UNITED STATES PATENT AND TRADEMARK OFFICE

APPLICATION NO.	FILING DATE	FIRST NAMED INVENTOR	ATTORNEY DOCKET NO.	CONFIRMATION NO.
10/727,509	12/05/2003	Claude Dube	87367.1800	7856

Office Action Summary	Application No. 10/727,509	Applicant(s) DUBE ET AL.	
	Examiner Noah C. Hawk	Art Unit 3637

Lakso, Figure 1 (detail)

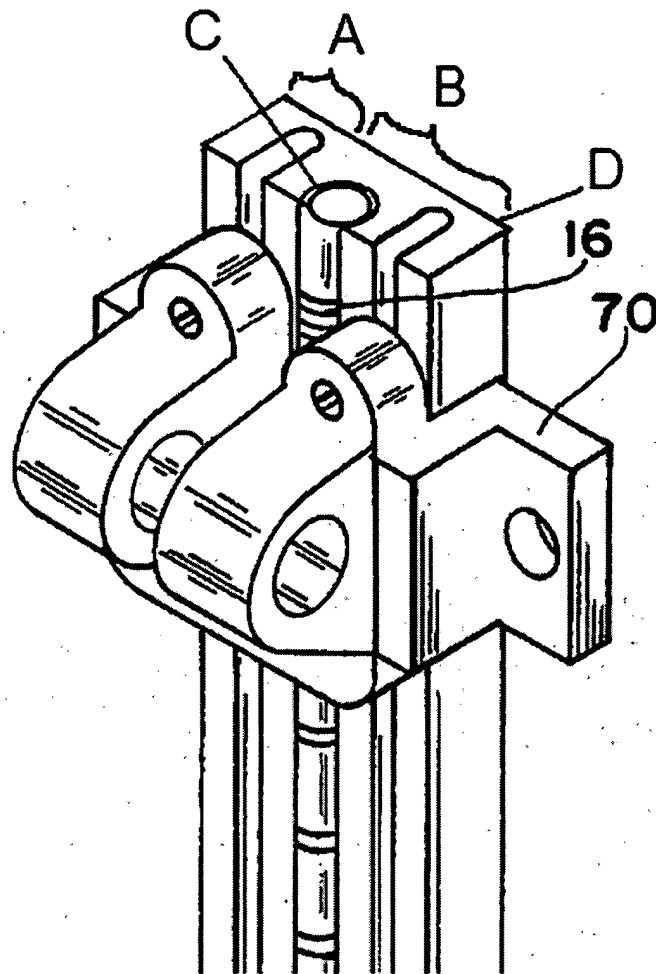
a. Regarding Claim 1, Lakso teaches an interlocking system for preventing simultaneous opening of drawers of a cabinet, comprising activation members (60) respectively affixable to back sides of the drawers; guide supports (20) respectively affixable in the cabinet behind the drawers, in respective registration with the activation members; an elongated track member (groove C, best seen in Lakso, Figure 1 detail, below) affixable in the cabinet on a side of the guide supports; a series of mobile blocks (14) slidably guided by the track member, the track member limiting the blocks to a partial displacement to produce a space between any two of the blocks; carriage members (30) respectively mounted on the guide supports, the carriage members being movable transversely to the track member, the carriage members respectively having bolt elements (50) projecting towards the track member and drivable one at a time in the space produced by the partial displacement of the blocks by sliding of the carriage members towards the track member; and coupling means (the

combination of 36, 40 and 64) respectively extending between the activation members and the carriage members for sliding one of the carriage members towards the track member using pulling motion of a corresponding one of the activation members during opening of a corresponding one of the drawers (the edge 44 of the carriage member moves toward the track member during the opening of a drawer), provided that the space is vacant for receiving the bolt element of said one of the carriage members, and sliding said one of the carriage members away from the track member using pushing motion of said one of the activation members during closing of said corresponding one of the drawers.

- b. Regarding Claim 2, Lakso further discloses that the coupling means (the combination of 36, 40 and 64) comprise guiding groove (the "apertural leaf" 64) and pin arrangements (pins 36 and 40) distributed between the activation members and the carriage members.
- c. Regarding Claim 9, Lakso discloses that the device further comprises a mounting structure (12) having opposite first (A, best seen in

Lakso, Figure 7

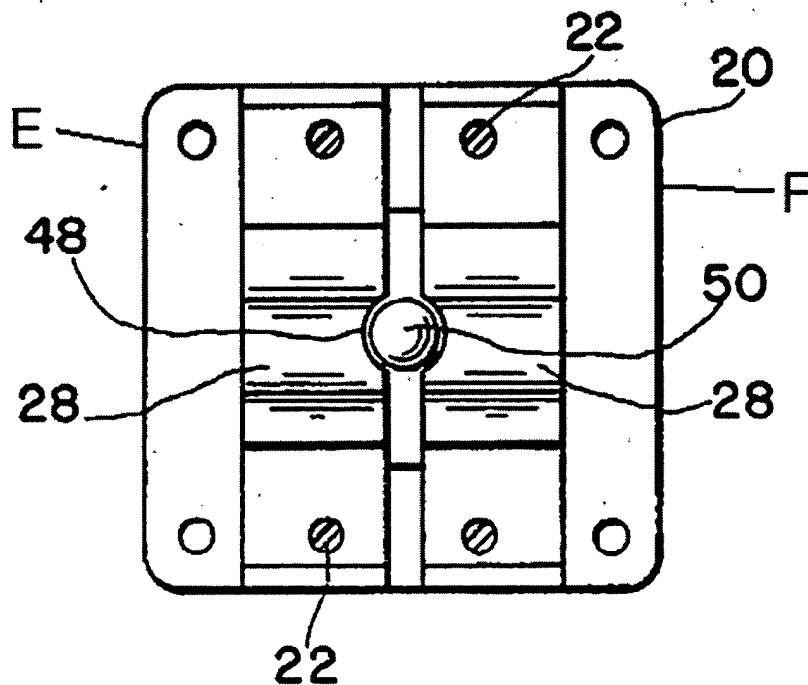
Lakso, Figure 1 detail) and second (B, best seen in Lakso, Figure 1 detail) mounting rails affixable in the cabinet behind the drawers and between which the guide supports are mountable (see Lakso, Column 2, lines 27-29), second mounting rail (B) providing a support structure for the track member (C).

d. Regarding Claim 10, Lakso further discloses that the guide supports have first (E) and second (F) opposite ends respectively attachable to the mounting rails (see Lakso, Column 2, lines 27-29) at adjustable heights along the mounting rails.

- e. Regarding Claim 12, Lakso further discloses that the mounting structure has a back wall (D) extending between the first and second mounting rails.
